Improved Rotary Cup Feed

TB5000-029

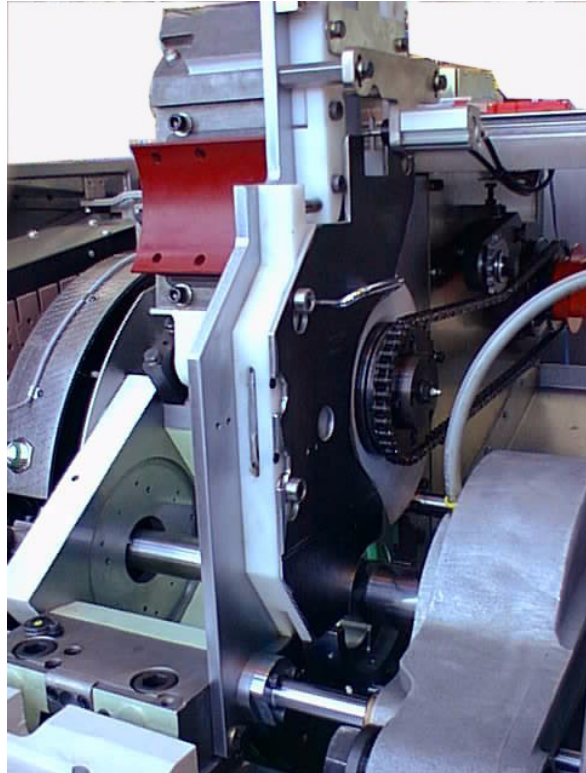
Summary: CarnaudMetalbox Engineering have with the aid of a high speed video camera developed an improved version of the Rotary Cup Feed Arrangement.

This up-grade gives a smoother peel off from the cup stack with superior guidance from both the Cam and Guides with more accurate loading and positioning of the cup in the Cup Locator.

The new Rotary Cup Feed design can be fitted to all 5000 Bodymaker machines within 12 hours. Minor Guard modifications may be necessary.
